LHC Beam Dump System (LBDS)

Report on the Audit held in January/February 2008

The LHC Beam Dump System

Report on the Audit held on January 28th to February 15th 2008

FMECA

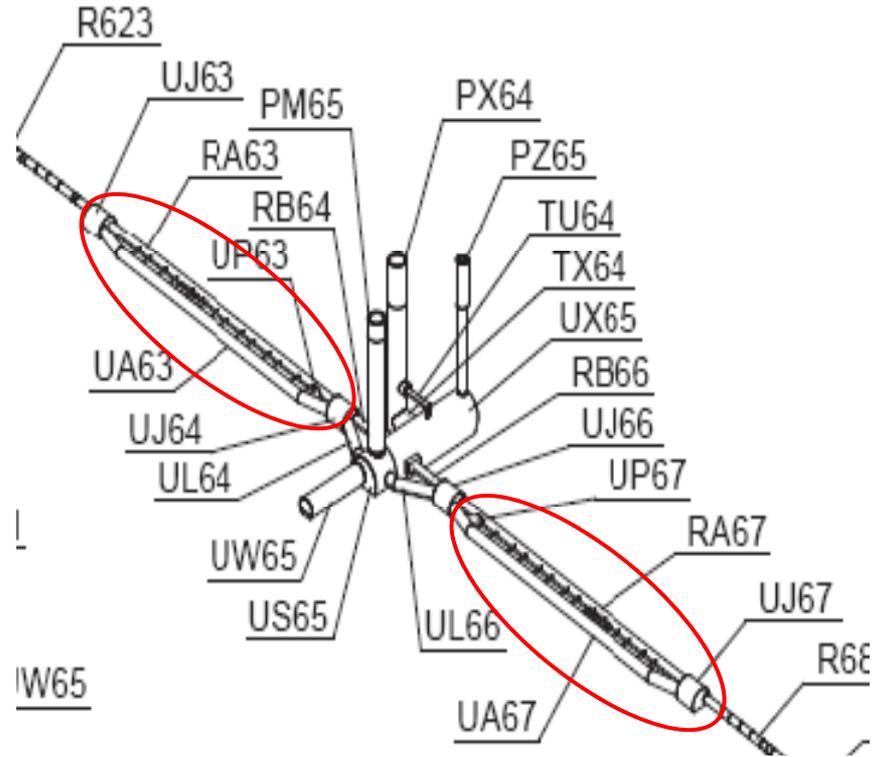
Magnet assemblies account for about 99.5% of the un-safety, while the trigger electronics covers the remaining 0.5%:

- 14. Since the focus of this review was on the trigger electronics, an independent review of the high power system components should be organised.

Radiation

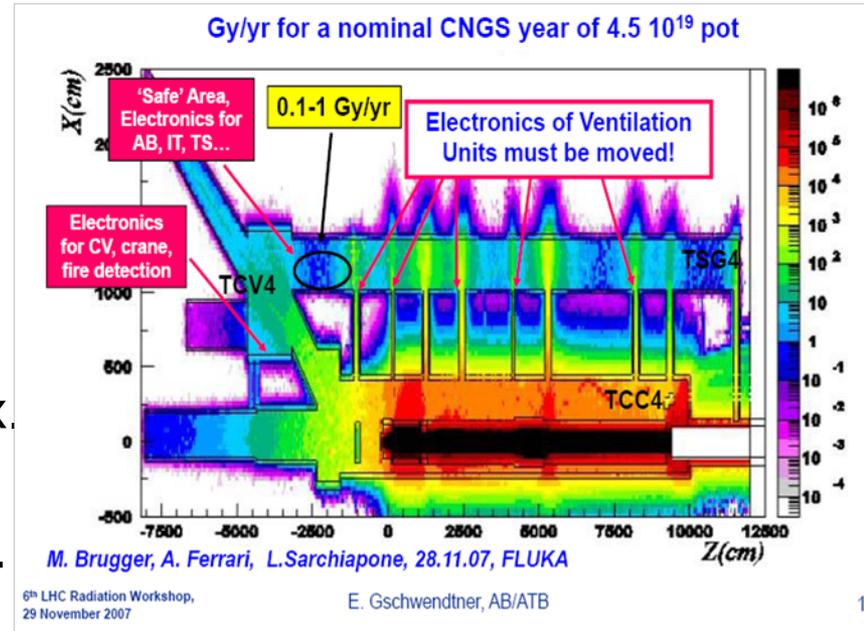
LBDS hardware installed in-line with cable ducts to kicker magnets:

- Radiation-tolerance not part of design
- SEEs in CMOS & FPGA hardware, VHDL & PLC code, look-up-tables...

22. Quantify risks due to SEEs & “aging”.

23. Simulations to determine expected flux.

24. Create list of susceptible components (e.g. CMOS on the critical signal path).

25. Together with SEE expert, perform irradiation experiments to identify failure modes and cross-sections.

26. Contact Xilinx FAE in order to quantify the risks of FPGA mal-function with the given flux.
